Staff Report

To: Development Review Board (DRB)
From: Christopher Yuen, Community Development Director
Meeting Date: 02/15/2024
Subject: 2 Lincoln St. (Lincoln Hall) Renovations Design Review

EXTERIOR ELEVATIONS

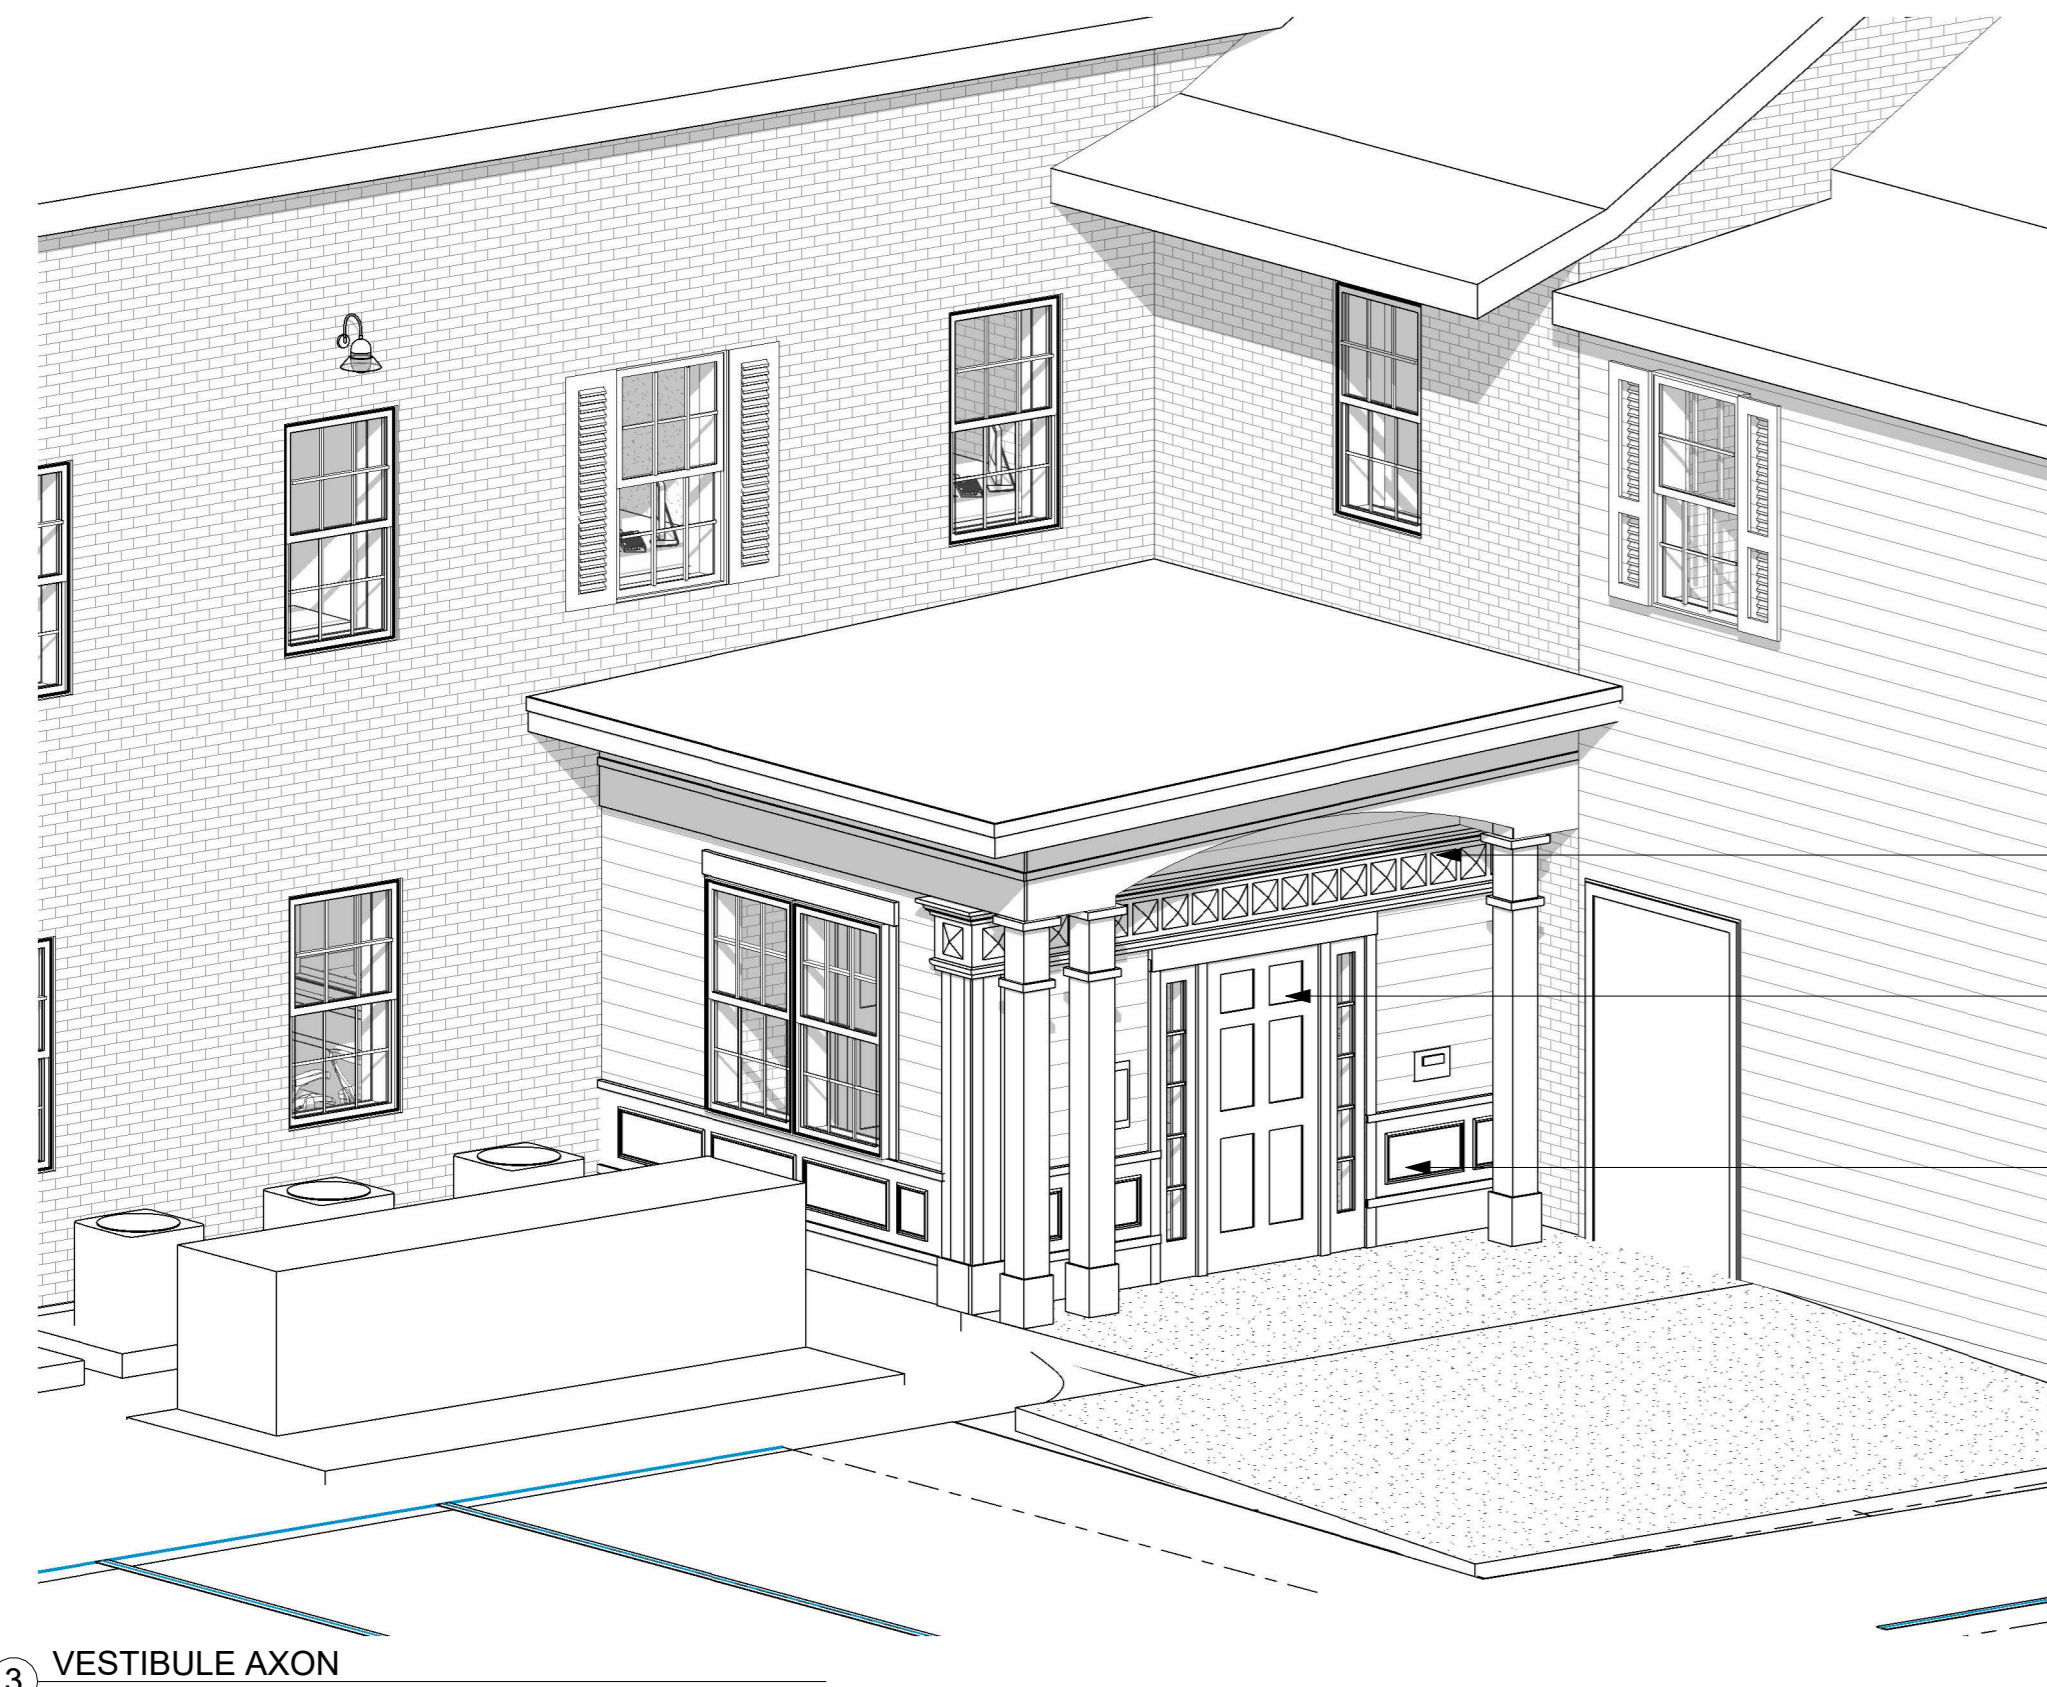
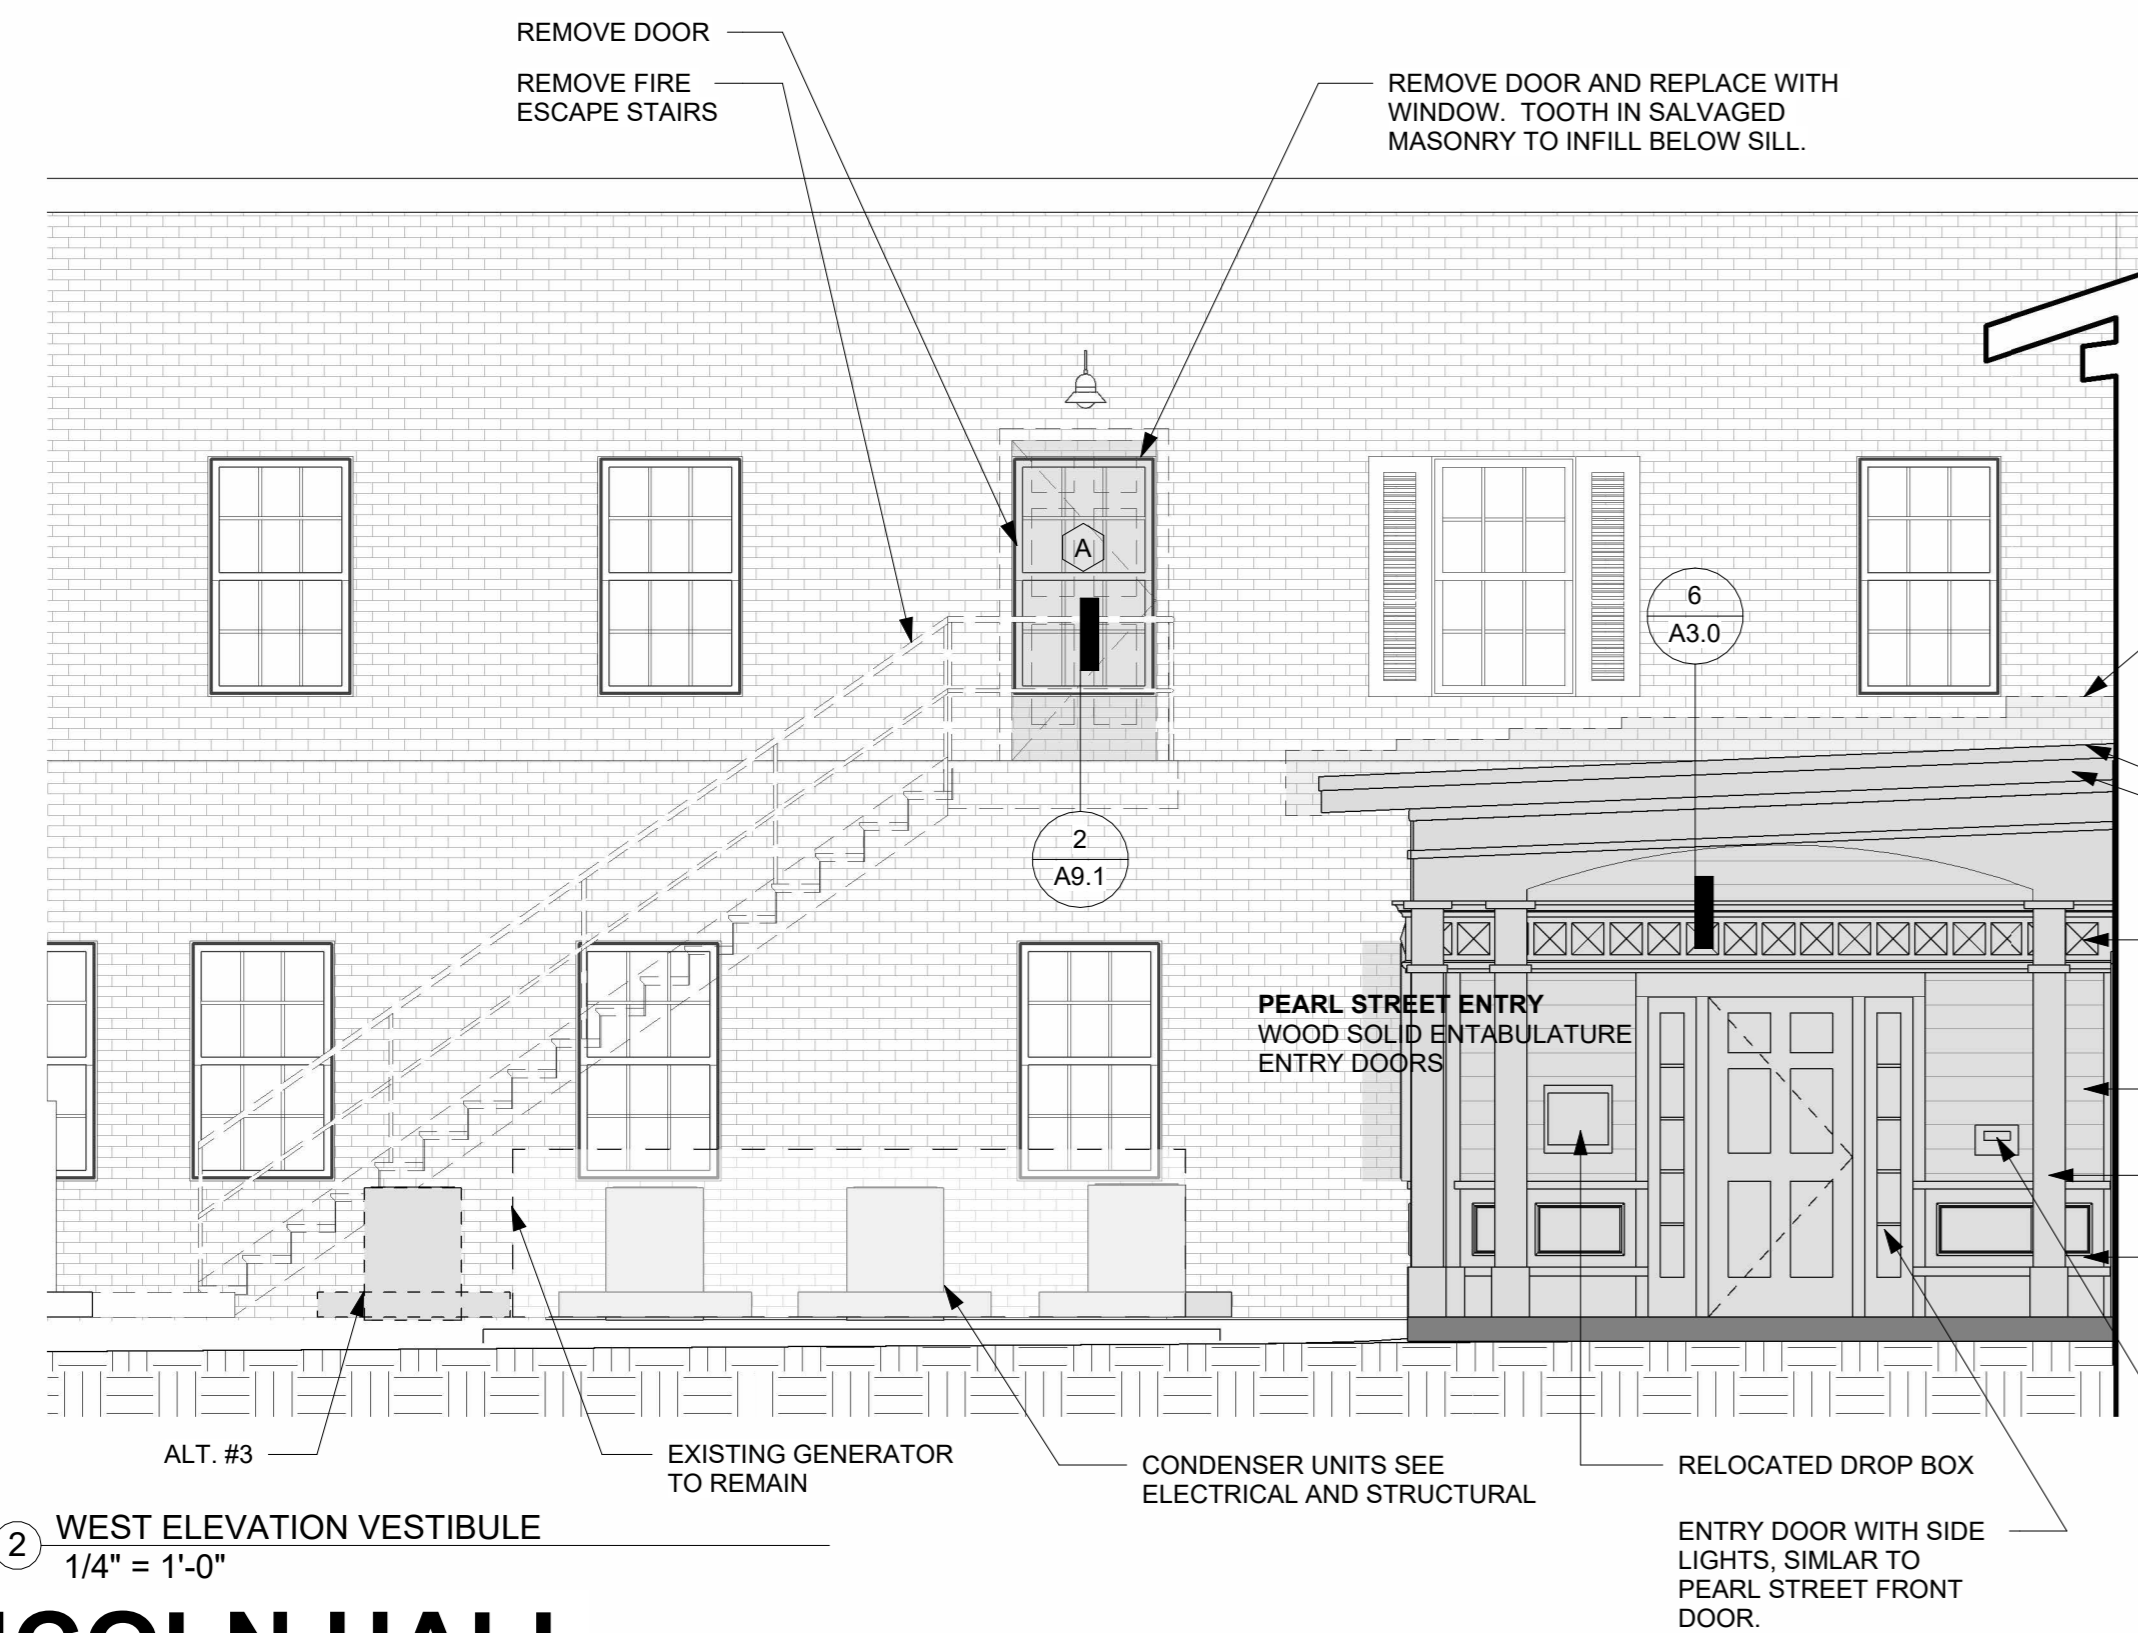
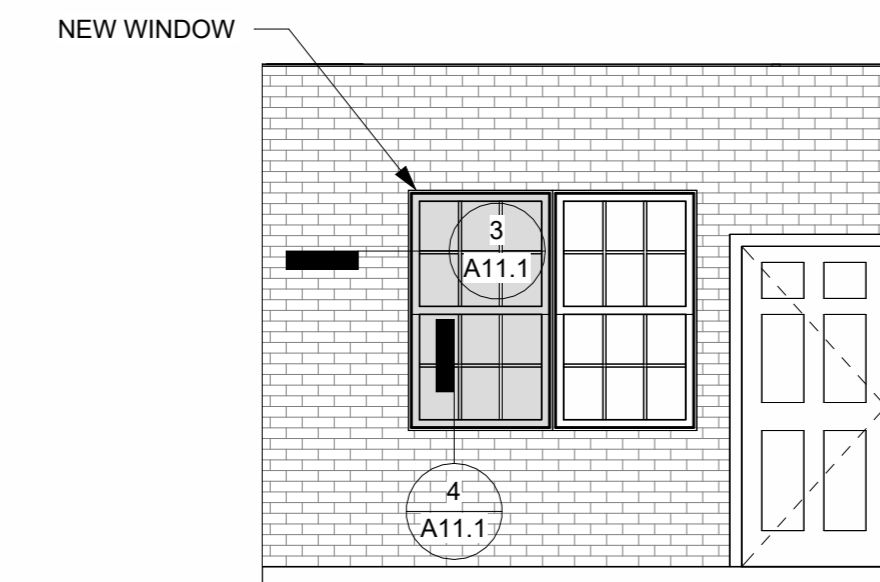
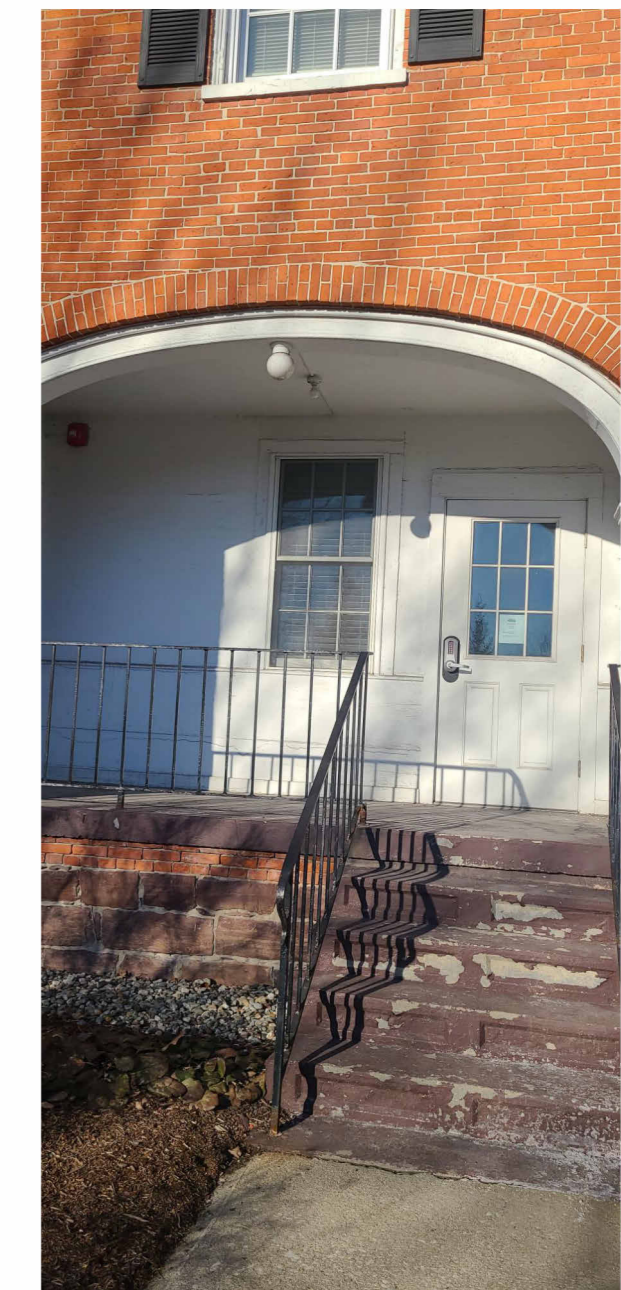
The addition of an entrance vestibule, the removal of exterior stairways, and the addition of exterior HVAC equipment is a modification and is therefore subject to design review.

The proposed exterior changes are not visible from the 5 Corners intersection, or anywhere along the street frontage. Staff notes that the proposed addition of the entrance vestibule is consistent with the style of the existing building.

Lincoln Hall has undergone many changes over time. The new additions are not expected to destroy any historic material that characterizes the property that still exist.

Staff recommends the DRB approve the proposed changes to the exterior of Lincoln Hall, at 2 Lincoln Street, if it determines that the requirements of Section 604.E are met.
